HISTORIC AND DESIGN REVIEW COMMISSION

HDRC CASE NO: 2020-205
ADDRESS: 125 W GRAMERCY PLACE
LEGAL DESCRIPTION: NCB 6382 BLK 2 LOT 6,7 & 8
ZONING: R-5,H
CITY COUNCIL DIST.: 1
DISTRICT: Monte Vista Historic District
APPLICANT: HICKS DALE & THERESA ERIN
OWNER: San Antonio San Antonio/HICKS DALE & THERESA ERIN
TYPE OF WORK: Exterior modifications to rear accessory structure
APPLICATION RECEIVED: May 03, 2020
60-DAY REVIEW: Not applicable due to City Council Emergency Orders
CASE MANAGER: Stephanie Phillips

REQUEST:

The applicant is requesting a Certificate of Appropriateness for approval to modify the existing front fenestration of the rear garage to include three single bay garage doors.

1 SOUTH ELEVATION - PROPOSED

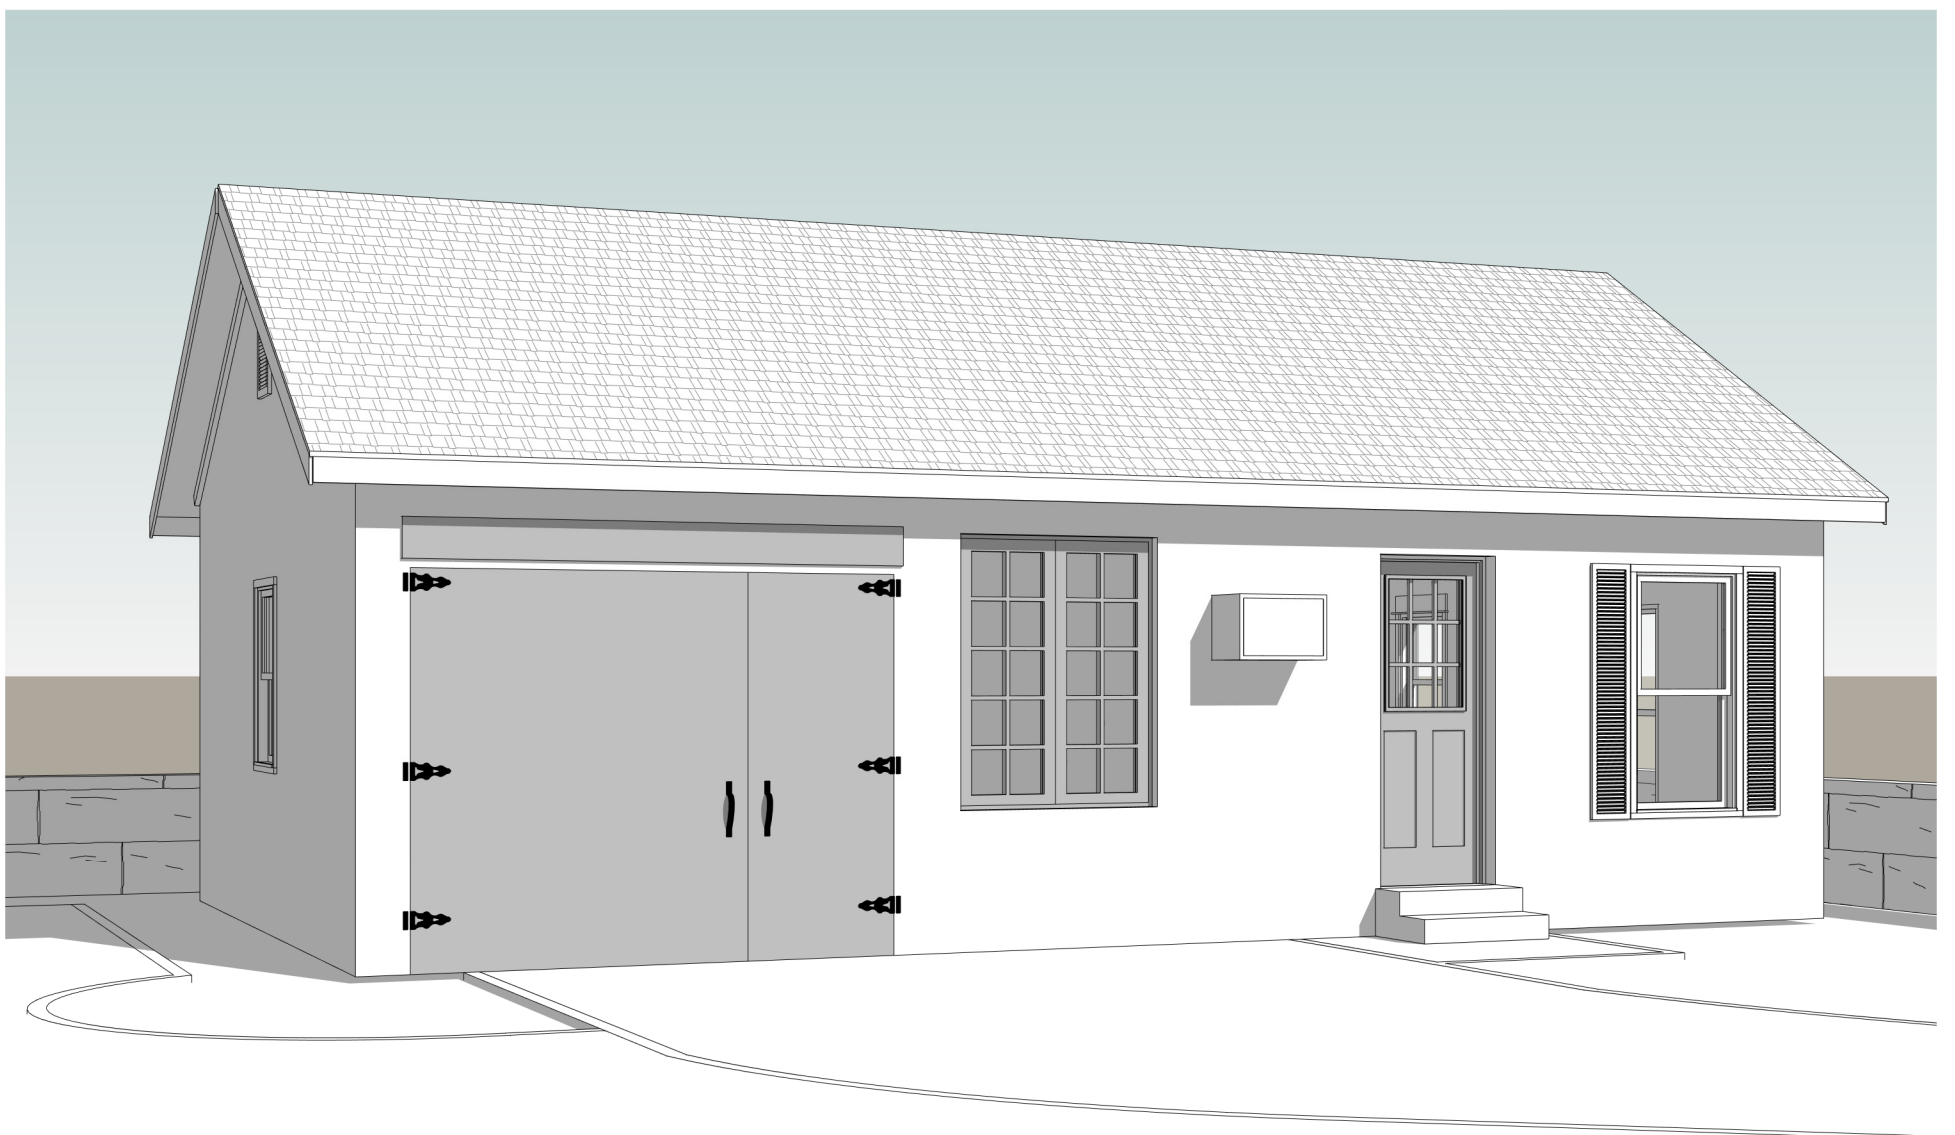
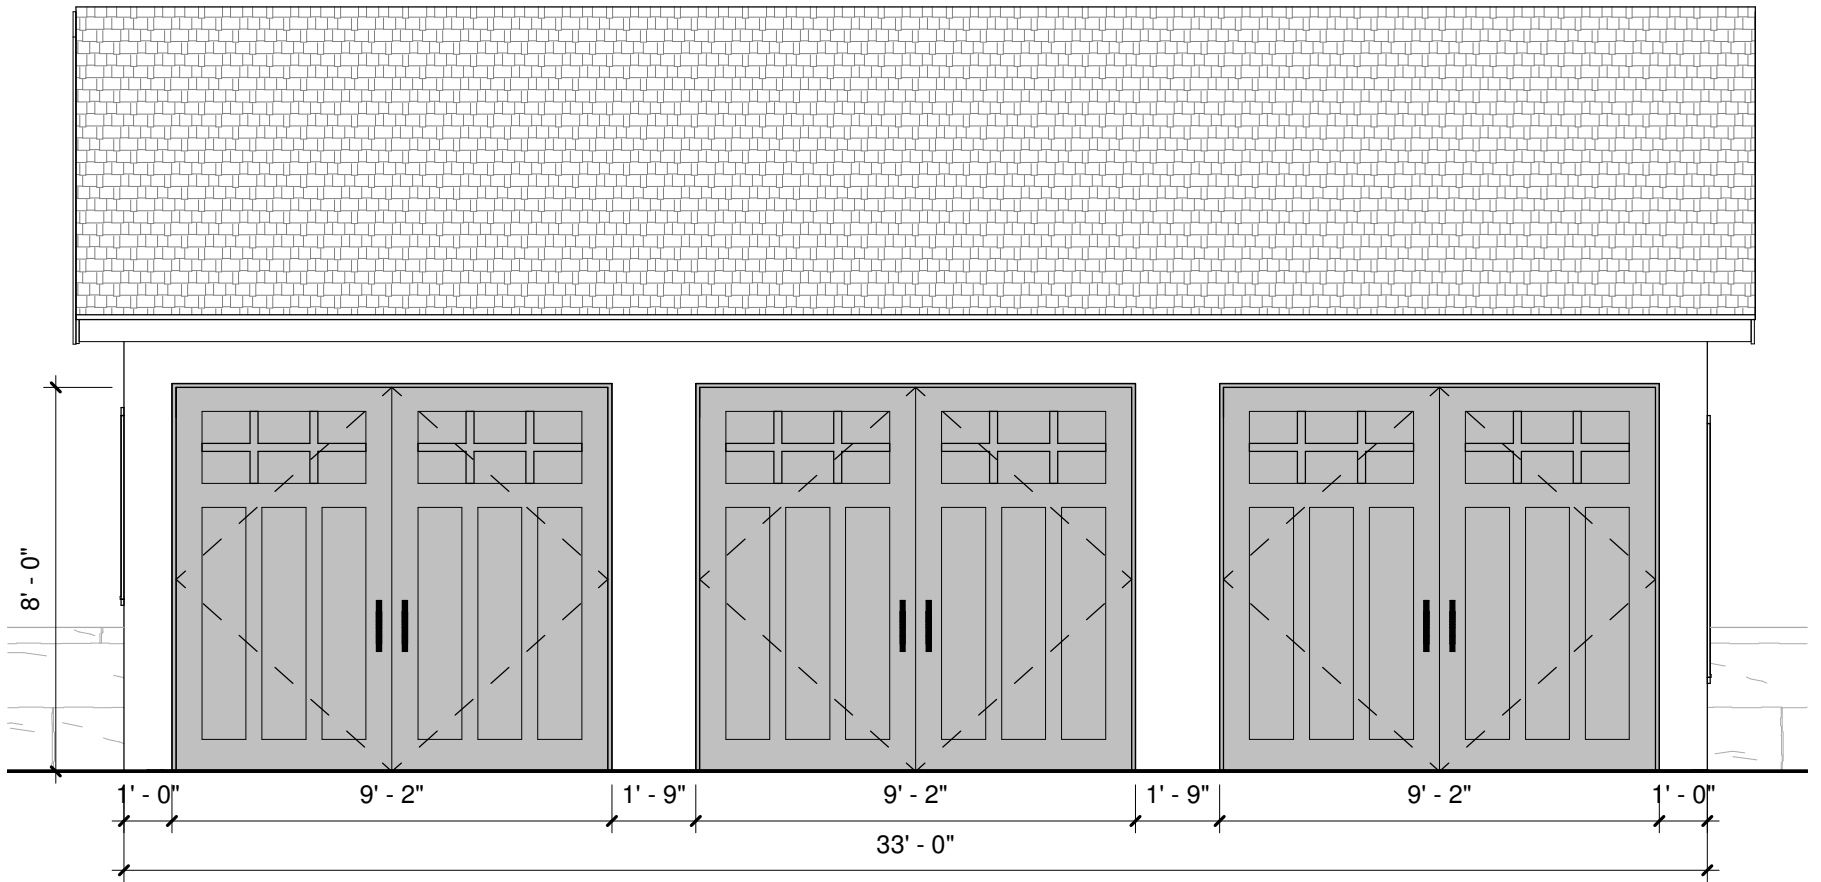
- b. **GARAGE MODIFICATIONS** – The applicant has proposed to modify the fenestration of the rear accessory structure. The structure currently contains a single bay garage door, pedestrain door with stairs, and windows. The window assemblies are not original and are not consistent with the Historic Design Guidelines. The applicant has proposed to modify the elevation to feature three single bay garage doors. The applicant provided original blueprints that indicate the original configuration of the garage featured two bays and a maids quarters. Based on these elevations, the easternmost third of the structure maintains its original configuration, including a window and a door with steps. According to the Historic Design Guidelines, existing openings should be preserved. Previous openings should be restored with sufficient documentation. Replacement garage doors should be compatible with those found on historic garages in the district (e.g., wood paneled) as well as with the principal structure. Staff finds that restoring the original second garage door bay is appropriate, but finds that installing a third bay where the maids quarter originally existed inappropriate.

- i. That the applicant retains the door, stairs, and window on the easternmost portion of the front elevation as noted in finding b. The applicant is required to submit updated drawings that reflect this change.
- ii. That the applicant submits accurate, measured, permit-level elevation and plan drawings to staff for review and approval prior to the issuance of a Certificate of Appropriateness.
- iii. That the applicant submits final material specifications for review and approval.
